INNER WEST

DEVELOPMENT ASSESSMENT REPORT

Application No.	DA/2020/0984
Address	160 Darling Street BALMAIN NSW 2041
Proposal	Alterations and additions to existing attached dwelling-house
Date of Lodgement	20 November 2020
Applicant	Mr John M Chatterton
Owner	Mr John M Chatterton Mrs Catherine J Chatterton
Number of Submissions	Nil
Value of works	\$300,000.00
Reason for determination at Planning Panel	Clause 4.6 variation to Floor Space Ratio exceeds 10%
Main Issues	FSR Variation Solar Access
Recommendation	Approval with Conditions
Attachment A	Recommended conditions of consent
Attachment B	Plans of proposed development
Attachment C	Clause 4.6 Exception to Development Standards
Attachment D	Statement of Heritage Significance

01 LONGITUDINAL SECTION
A06 PROPOSED 1:100

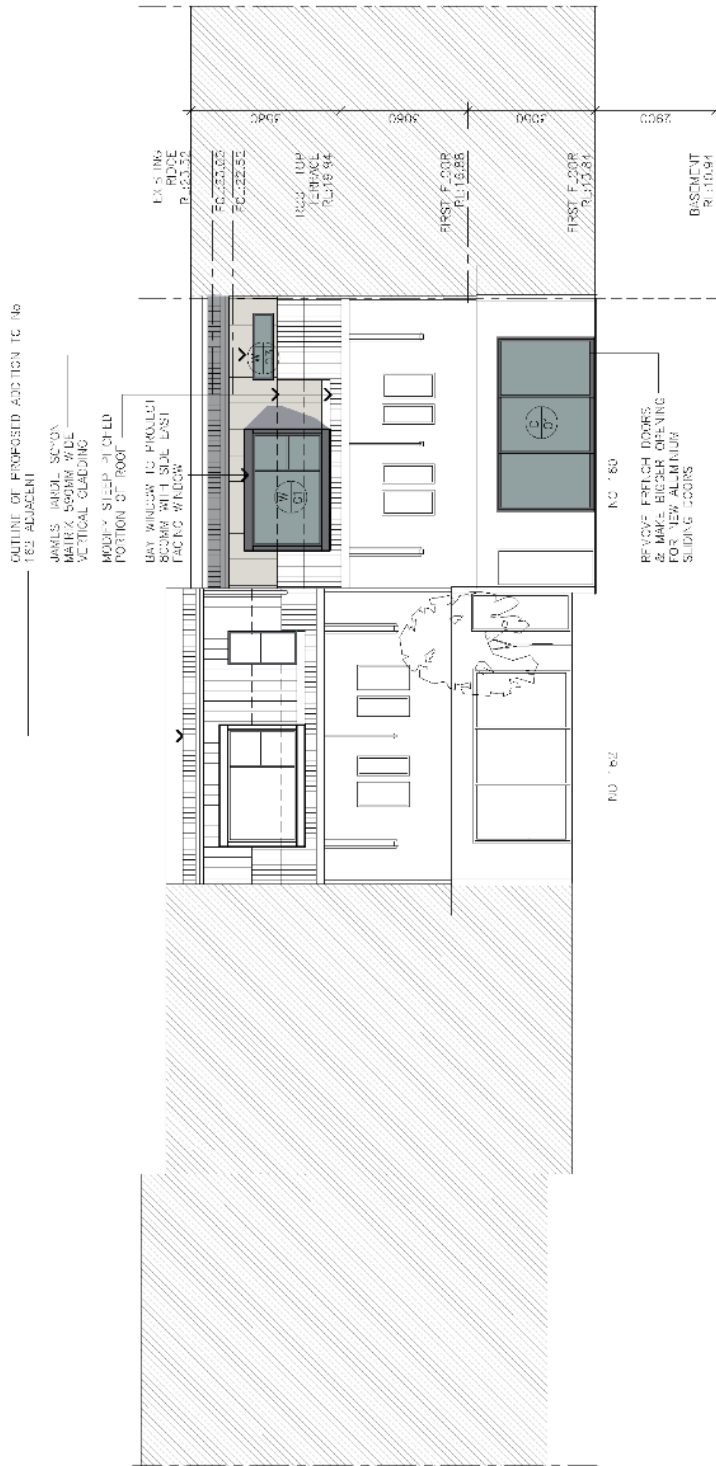
The additional building bulk, form and volume is illustrated on Dwg. No. A06 albeit in 2-dimensional form and it is confined to the area of the proposed master bedroom. The bedroom is setback from the southern end walls of the floor below (to the edge of planter) as well as below and behind the dwelling's ridge.

01 PROPOSED REAR/SOUTHERN ELEVATION
A07

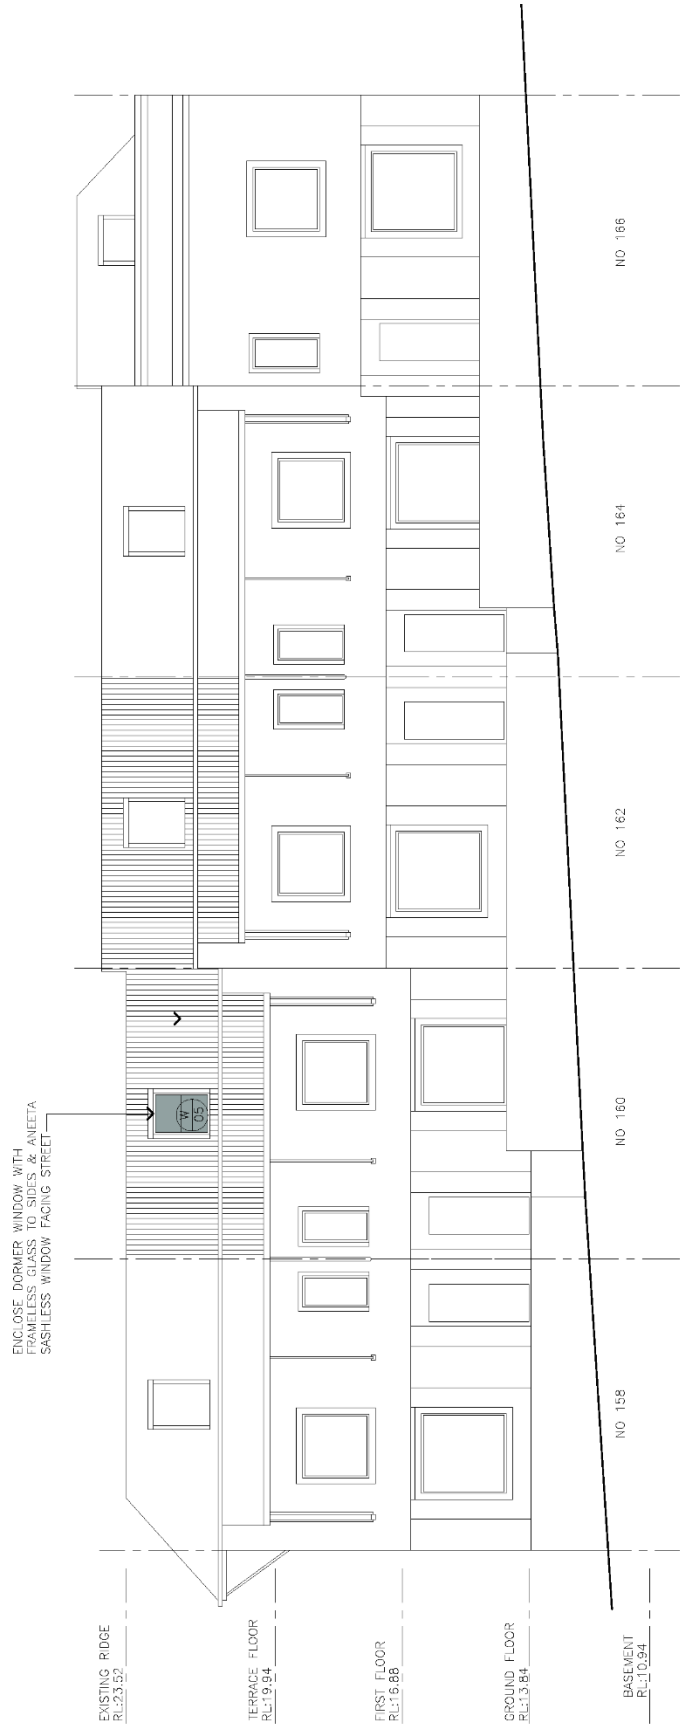
REMOVE BENCH DOORS
& MAKE BIGGER OPENING
FOR NEW ALUMINIUM
SLIDING DOORS
